Mt Welcome responses to section 51 and 53 comments

Project title: Mt Welcome

The following is a set of responses to ecological queries and comments raised by GWRC, DOC and PCC, usually through a consulting expert. Having said that the following also in effect addresses most if not all of the ecological matters raised by Te Runanga o Toa Rangatira, The Wellington Conservation Board, Friends of Taupo Swamp, and the PCC planning report.

Figure 2 The mapped feature in the Assessment (Figure 6 feature 34).

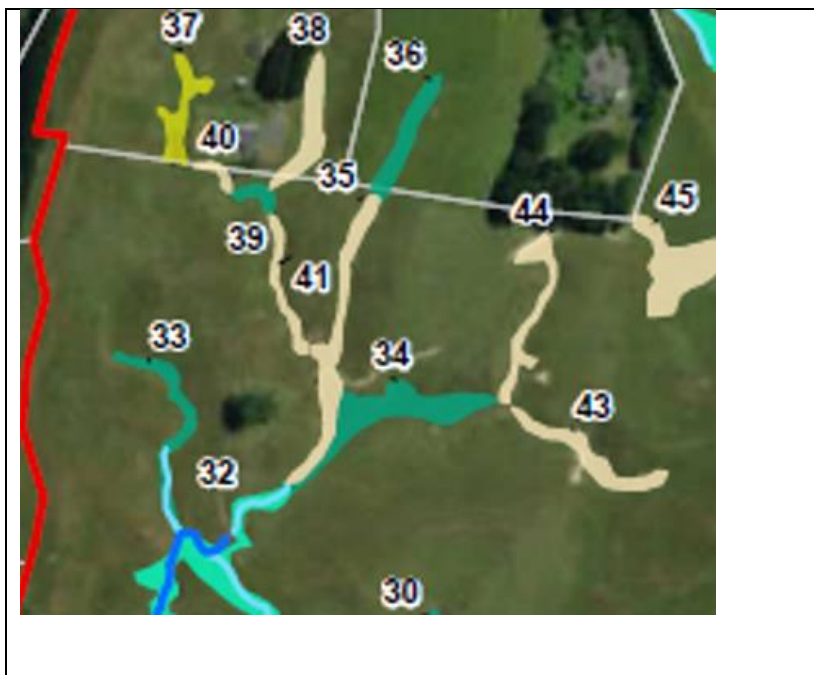
The new proposed indigenous wetland that will replace this mud sponge wetland (Figure 2) requires a downstream bund to retain the limited water present and to create a standing water reed wetland (*Raupo*, *Eleocharis*, *Machaerina* - with sedgeland edges). The "pipe" joining the wetland and downstream is to facilitate flow discharge from the wetland but not drain it. Because the bund is designed to facilitate the maintenance of the reed wetland (at around 300-500m standing water) it cannot contain a continual flow down the pipe at all times in all seasons because the pipe is set high enough to not drain the wetland completely. This means fish passage cannot be always facilitated by the pipe, but it will provide fish passage during the important migration periods.

In short there is no reasonable habitat currently for fish populations and it is an area all of 85-90m long and 10m wide at most. The new wetland, while a good fish habitat cannot technically be created to have unassisted fish passage at all times (otherwise it could be drained entirely), but will have passage during important migration periods.

Area 34 (Figure 2, Figure 3) a fully vegetated, no standing water, no channel, semi-pasture with spongy mud floating macrophyte natural inland wetland.

Figure 3 Overlooking the central wetland position of proposed wetland A, in summer and in winter after rain.

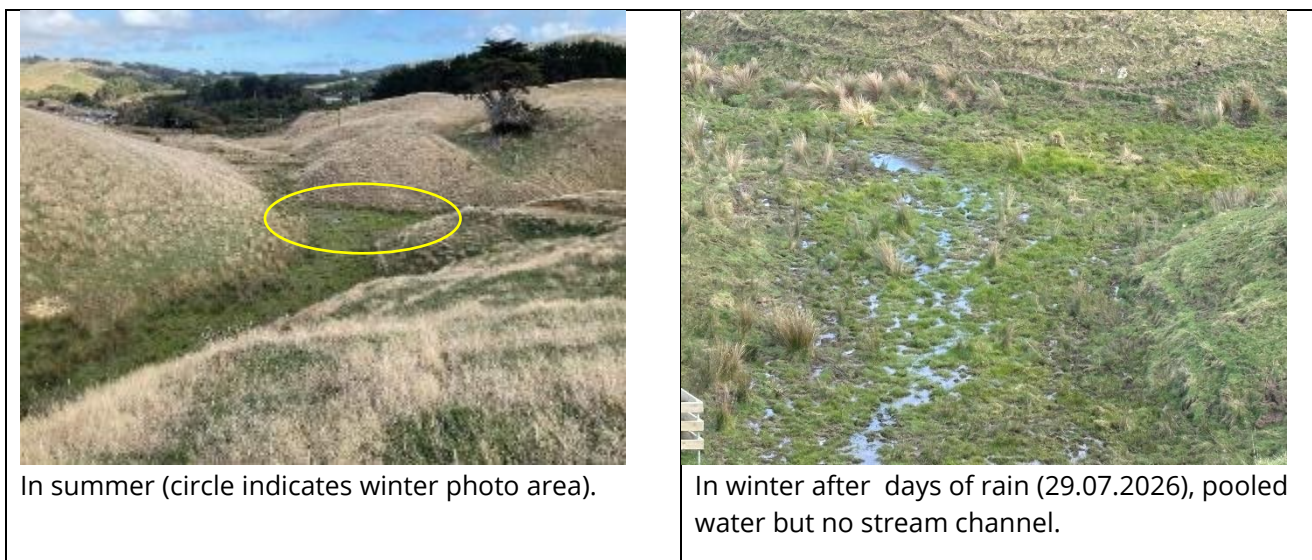
This generally is the story with the other features requested – wetland C and D and culvert P-39.

Figure 5: Winter 2026 (July) post rain photos of particular features.

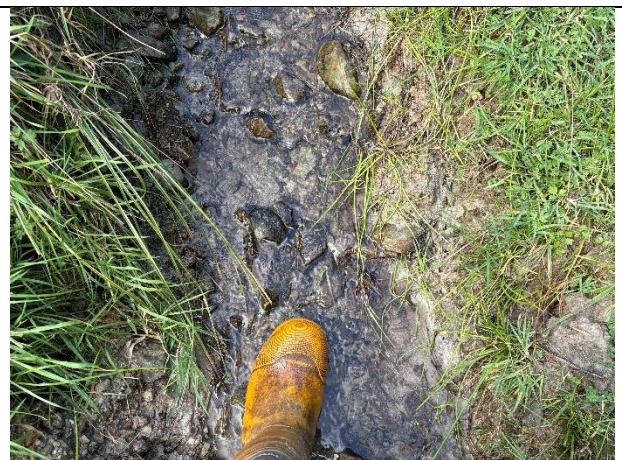
Upper end of main tributary with perched track culvert.
